Rainforth Grau Architects Project No. 2015-1225.00
 DSA File and Application No. 34-53/02-115661
 PTN: 67439-338

ADDENDUM NO. 01

Sutter Middle School - HVAC Replacement
 Sacramento, California

Partial Roof Framing Plan - Unit D SUTTER MIDDLE SCHOOL - HVAC REPLACEMENT SACRAMENTO CITY UNIFIED SCHOOL DISTRICT SACRAMENTO, CA DSA APP.02-115661 FILE NO. 34-53		DATE: 11/10/17 PROJECT NO.: 15-1225 SHEET: AD1.02 REF. S2.4.0
--	--	---

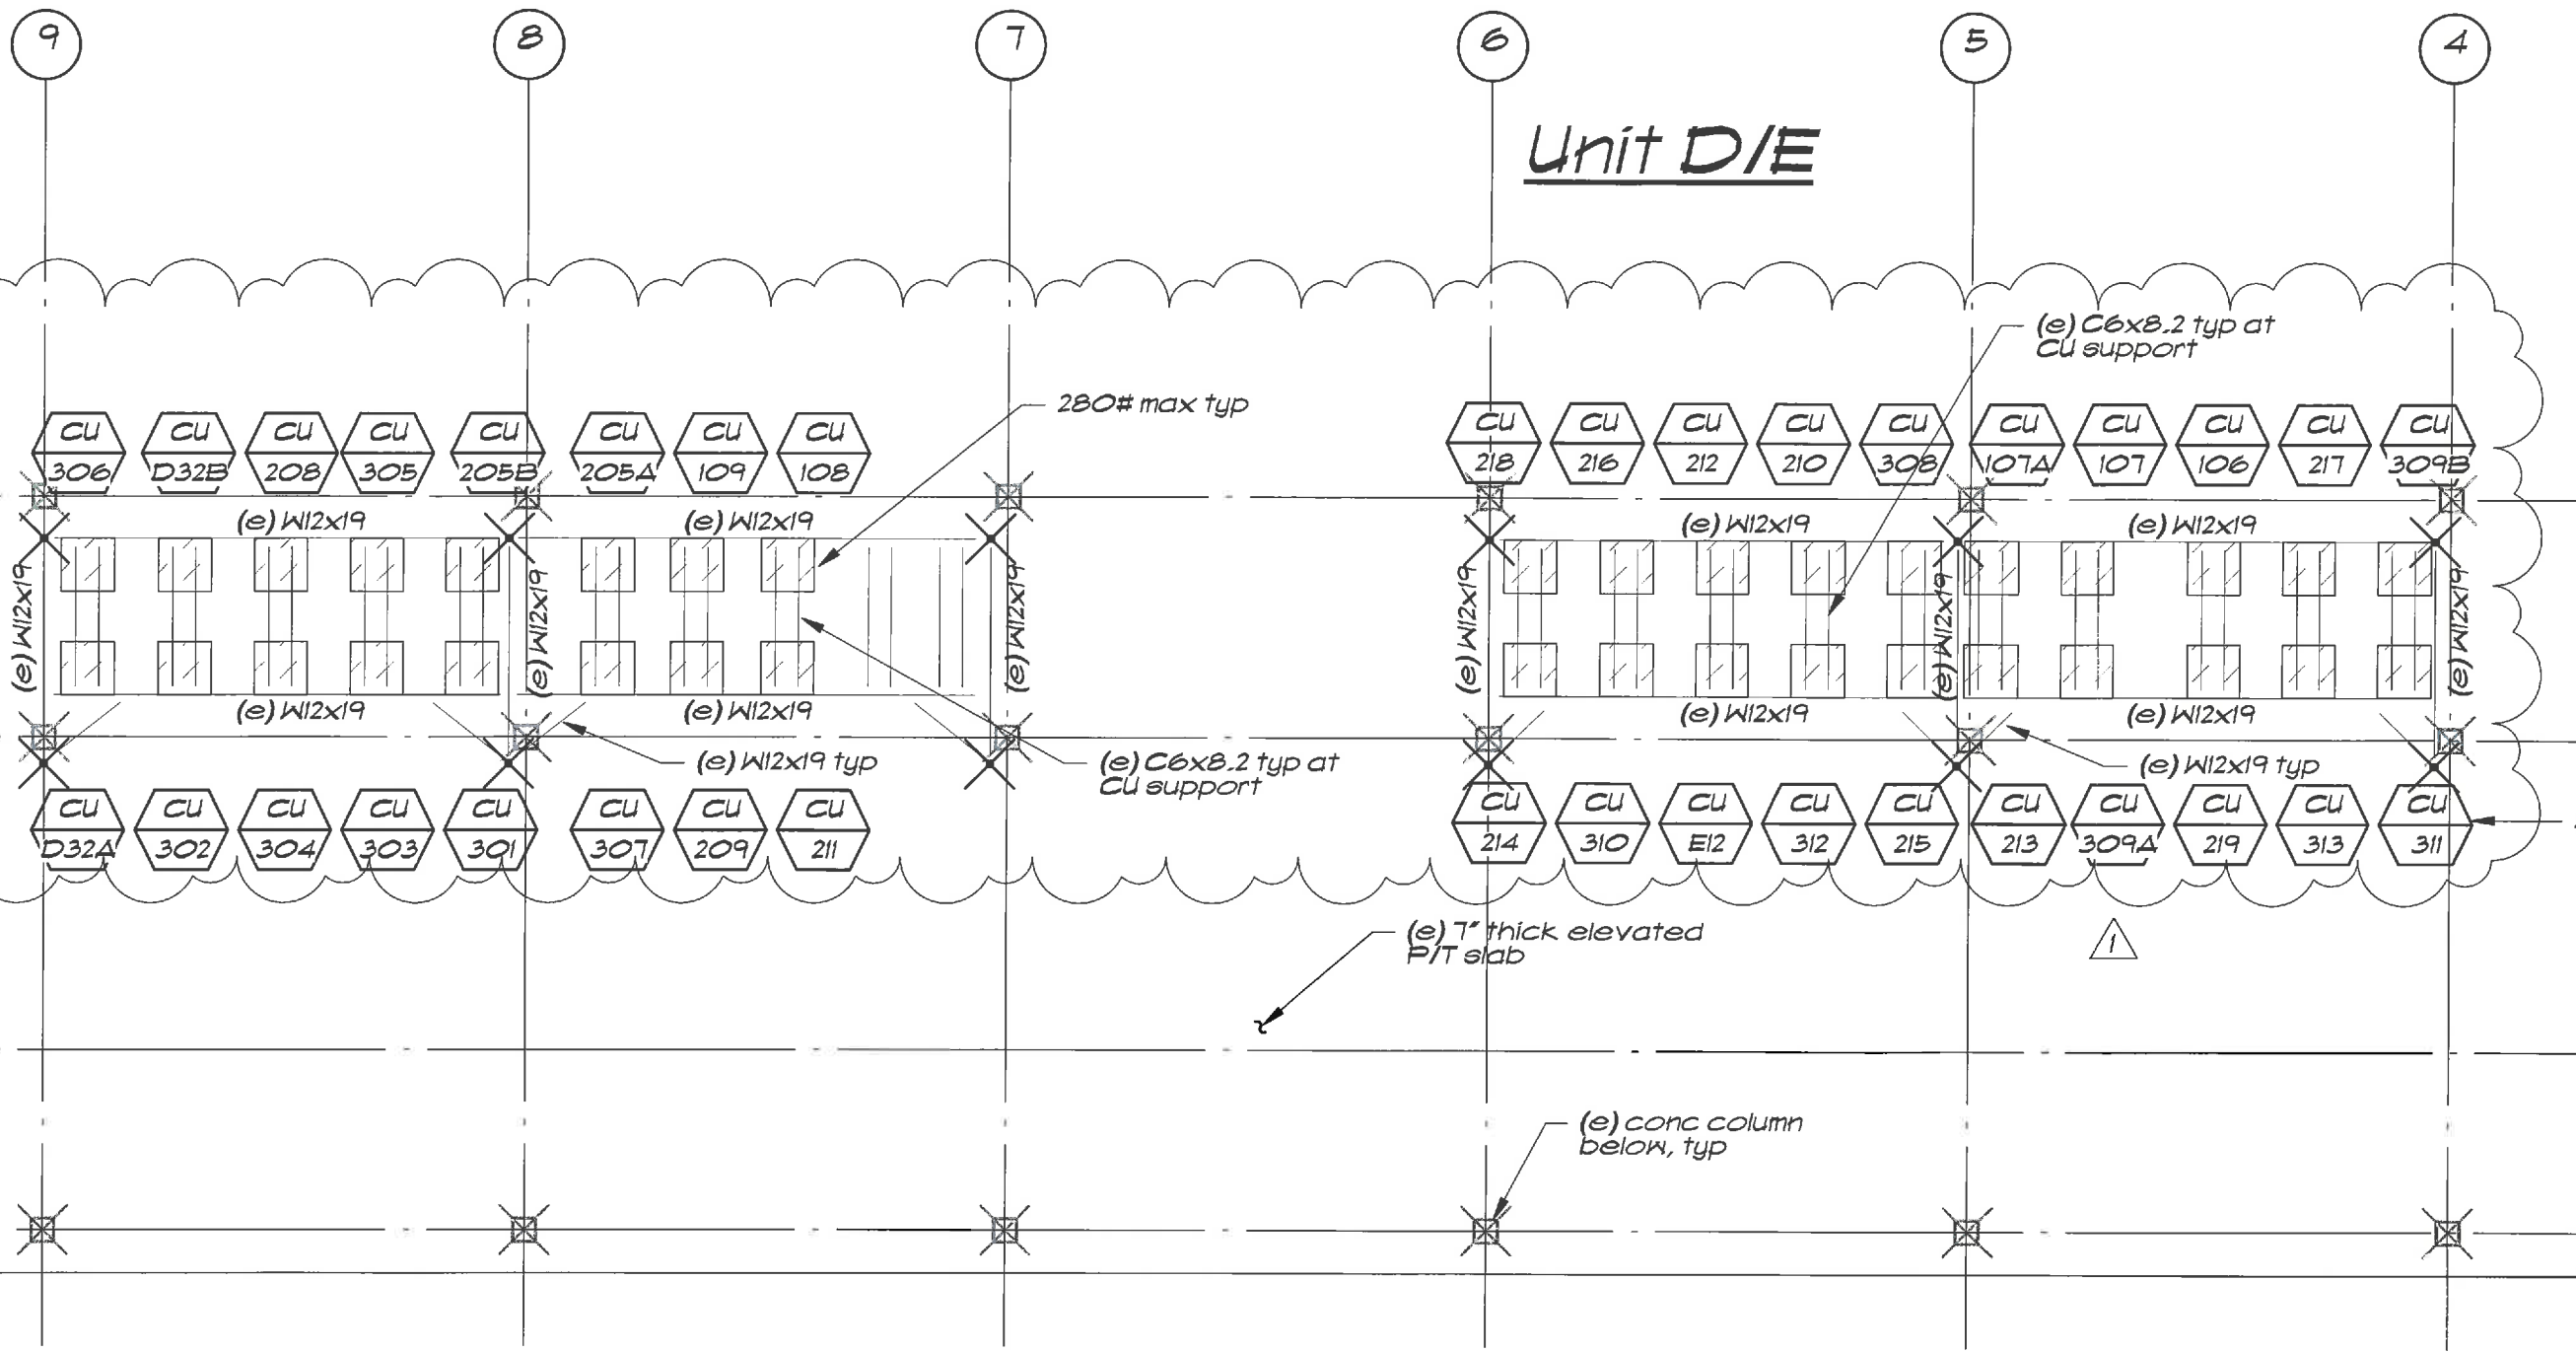
1. REVISE Roof Framing Plan per drawing AD1.02 included with this addendum.

MECHANICAL UNIT A & B FLOOR PLAN	DATE: 11/10/17
SUTTER MIDDLE SCHOOL - HVAC REPLACEMENT	PROJECT NO.: 15-1225
SACRAMENTO CITY UNIFIED SCHOOL DISTRICT SACRAMENTO, CA DSA APP.02-115661	SHEET: AD1.04 REF M2.1.0
FILE NO. 34-53

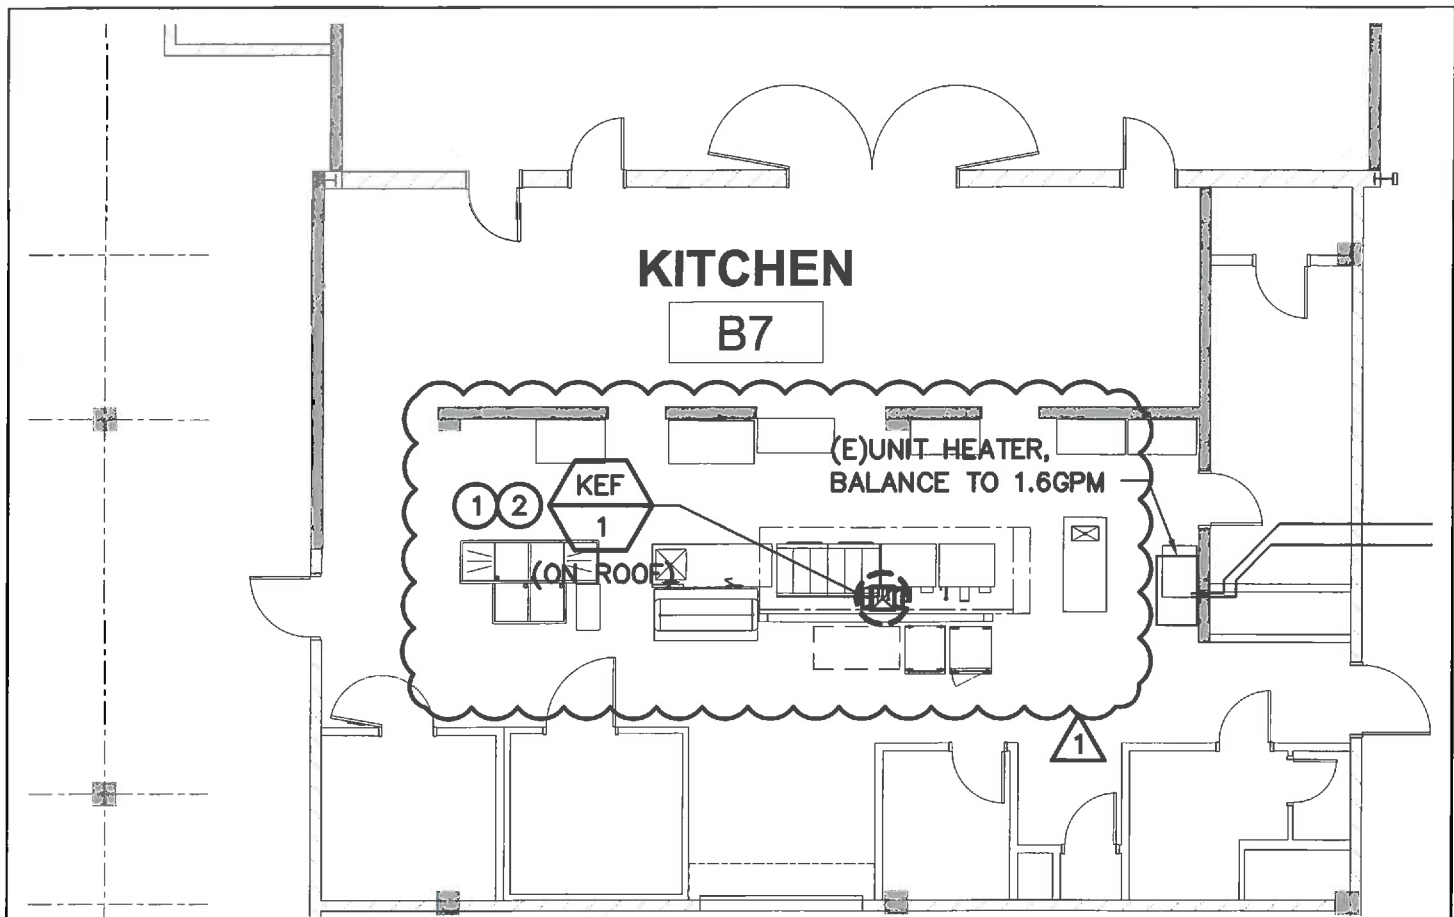
- J. Sheet M2.1.0, Mechanical Unit A and B, Floor Plan
 - 1. REVISE Floor Plan per drawing AD1.04 included with this addendum.
- K. Sheet M5.2, Mechanical Details

FLUE VENT THRU ROOF PIPING

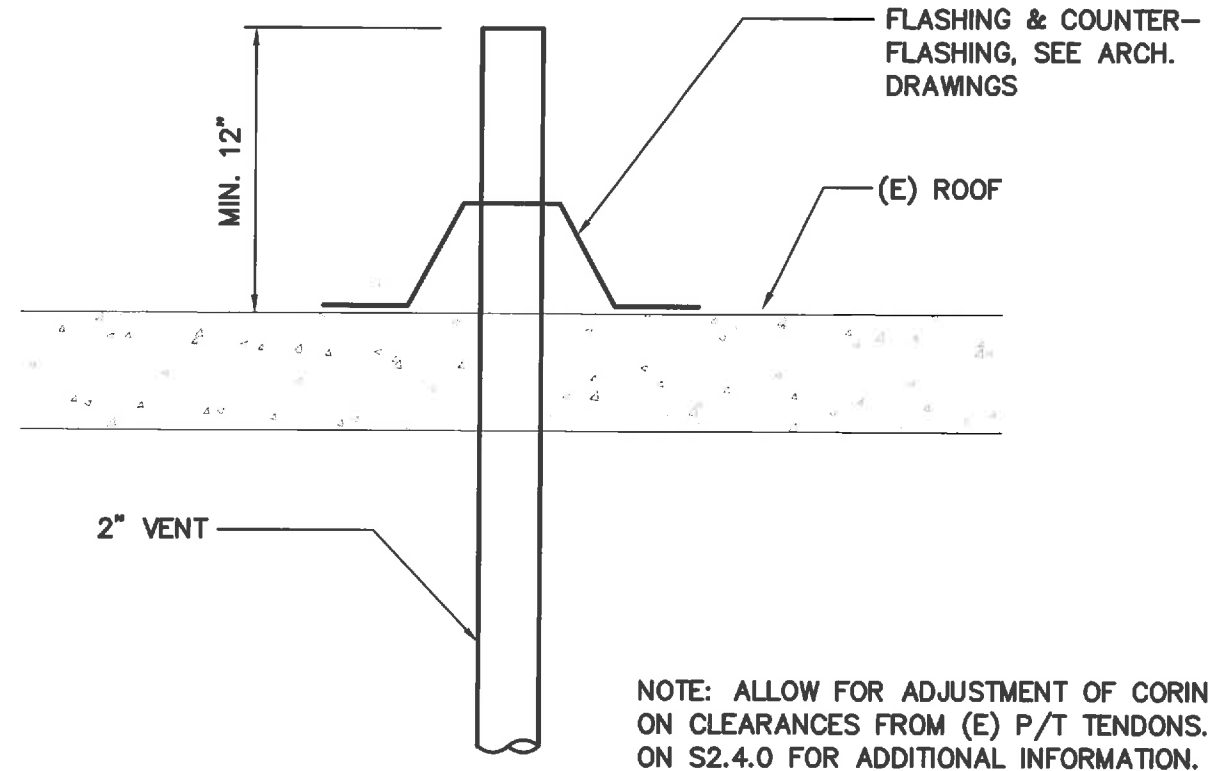
- 1. DELETE Detail 4, Combustion Air and Flue Vent Through Wall in its entirety and REPLACE with Detail 4/M5.2 per drawing AD1.05 included with this addendum.

NOTE: ALLOW FOR ADJUSTMENT OF CORING LOCATIONS BASED ON CLEARANCES FROM (E) P/T TENDONS. SEE GENERAL NOTES ON S2.4.0 FOR ADDITIONAL INFORMATION.

DATE: 11/10/17
PROJECT NO.: 15-1225
SHEET: AD1.05
REF M5.2

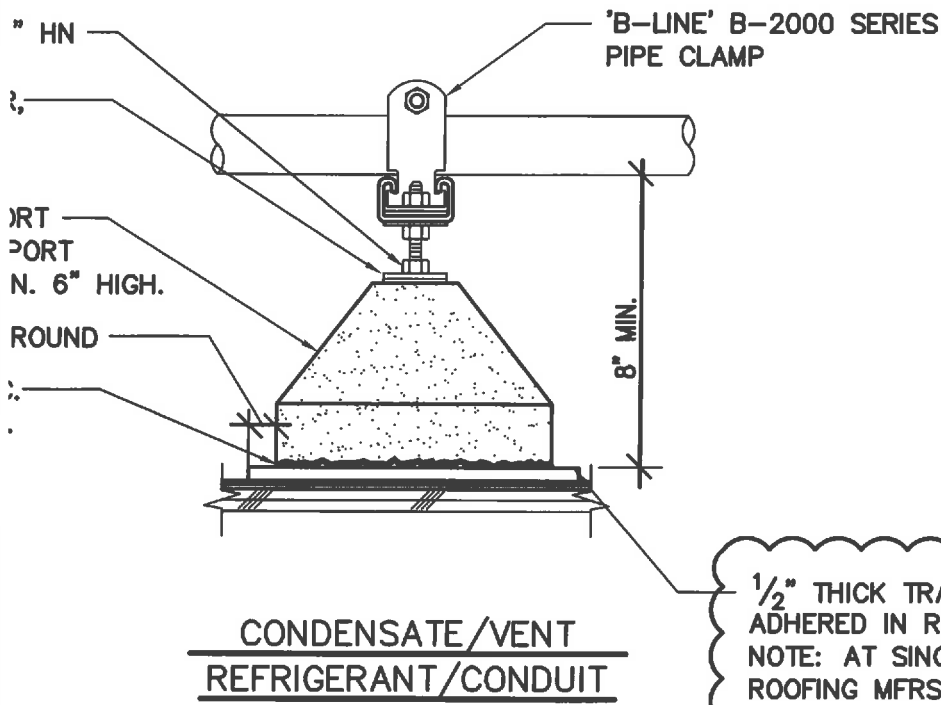
- 2. REVISE Detail 7, Pipe on Roof Mounting Detail per drawing AD1.06 included with this addendum.
- L. Sheet M6.3, Mechanical Control Diagrams
 - 1. REVISE (E) Exhaust Fan Control per drawing AD1.07 included with this addendum.

PLUMBING UNIT D FIRST FLOOR PLAN SUTTER MIDDLE SCHOOL - HVAC REPLACEMENT SACRAMENTO CITY UNIFIED SCHOOL DISTRICT SACRAMENTO, CA DSA APP.02-115661 FILE NO. 34-53	DATE: 11/10/17
	PROJECT NO.: 15-1225
	SHEET AD1.08 REF P2.3.1

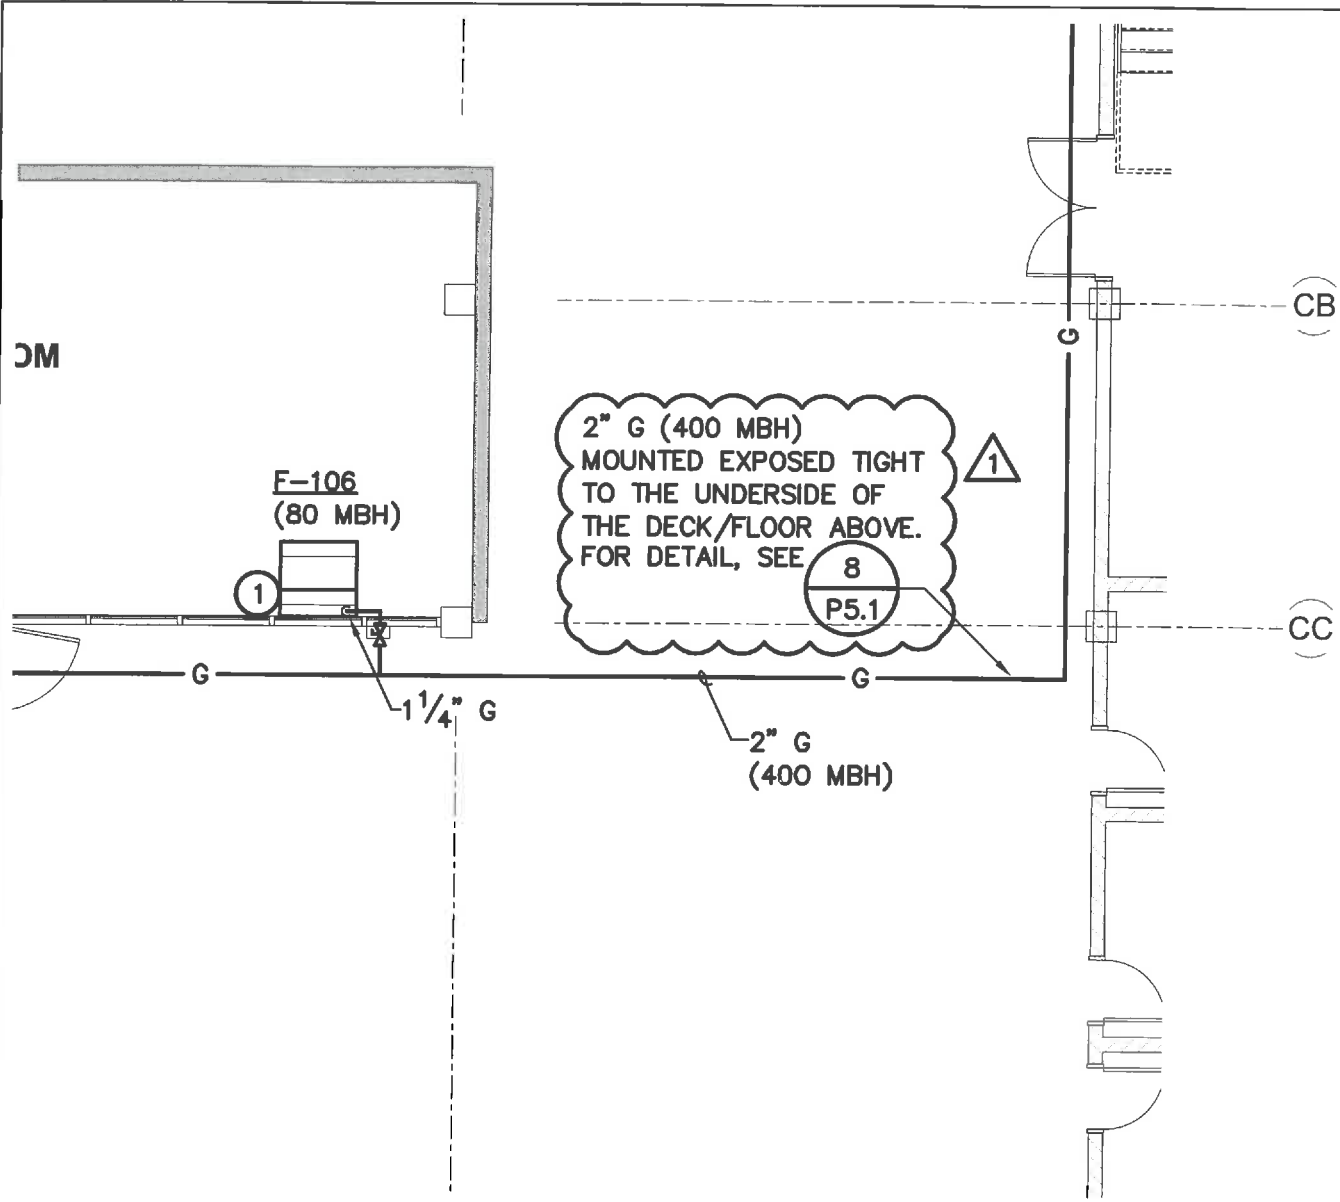
1. REVISE this sheet per drawing AD1.08 included with this addendum.
- N. Sheet P2.3.3, Plumbing Unit D, Third Floor Plan
1. REVISE Third Floor (East Side) Plan per drawing AD1.09 included with this addendum.

DATE: 11/10/17
 PROJECT NO.: 15-1225
 SHEET: **AD1.11**

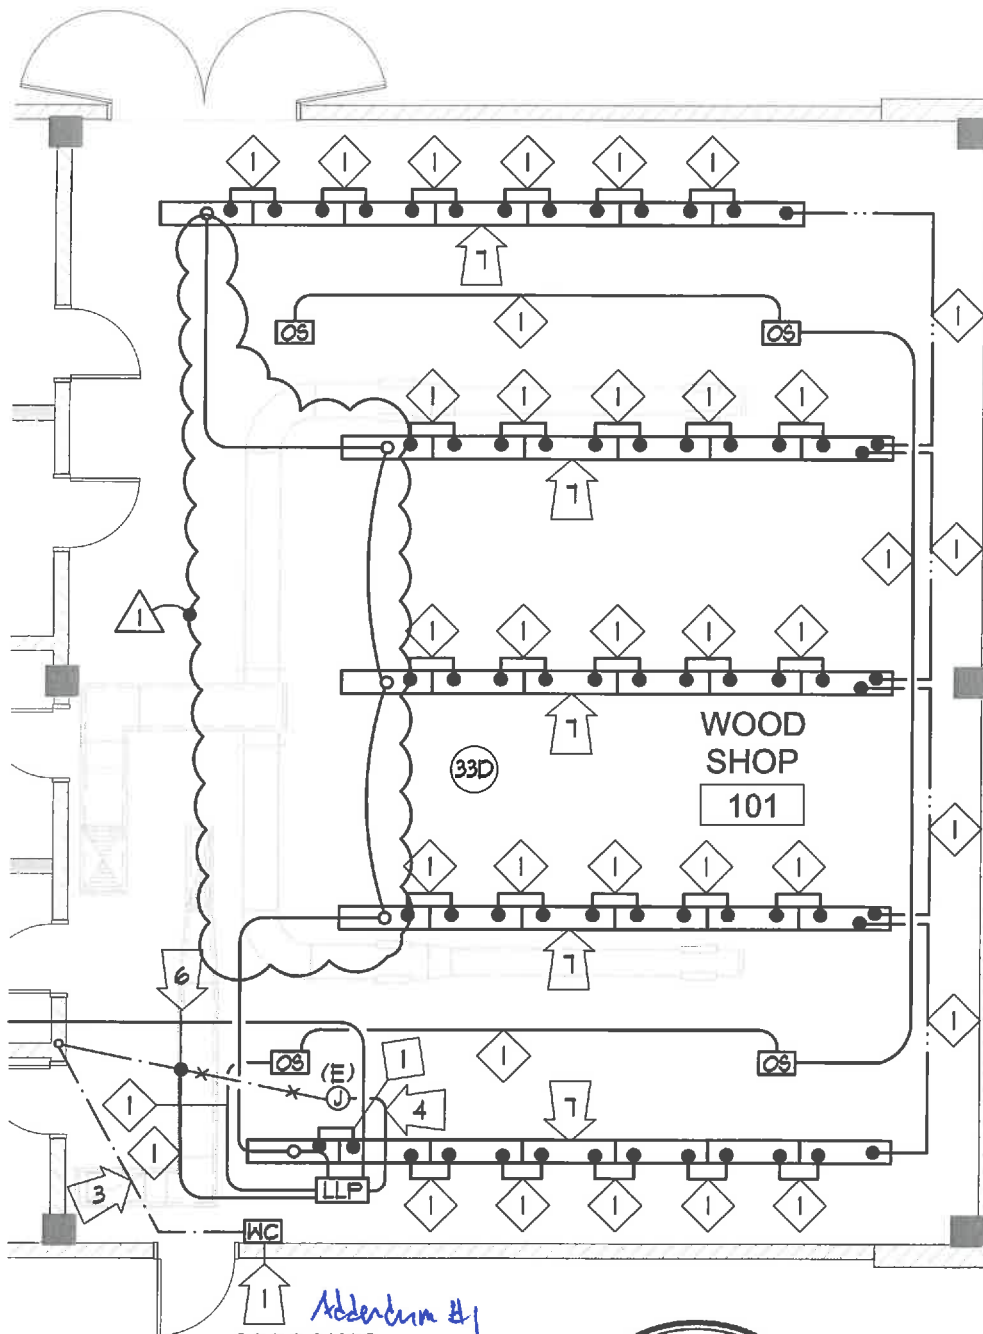
- O. Sheet E0.2, Electrical Interior, Title 24
1. REVISE this sheet per drawings AD1.10 and AD1.11 included with this addendum.
- P. Sheet E3.1.2, Unit C – Lighting Floor Plan

Unit C Lighting Floor Plan - E3.1.2

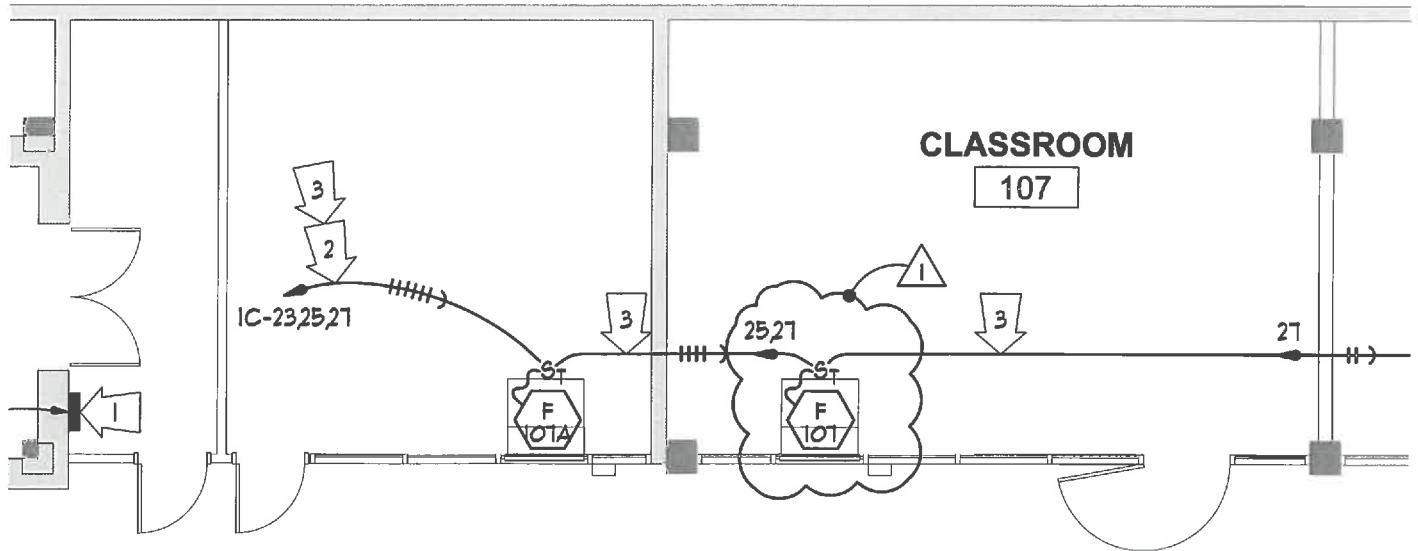
1. REVISE this sheet per drawing AD1.12 included with this addendum.
- ~~Q. Sheet E4.1.2, Unit C – Power Floor Plan~~
- ~~1. REVISE this sheet per drawing AD1.13 included with this addendum.~~
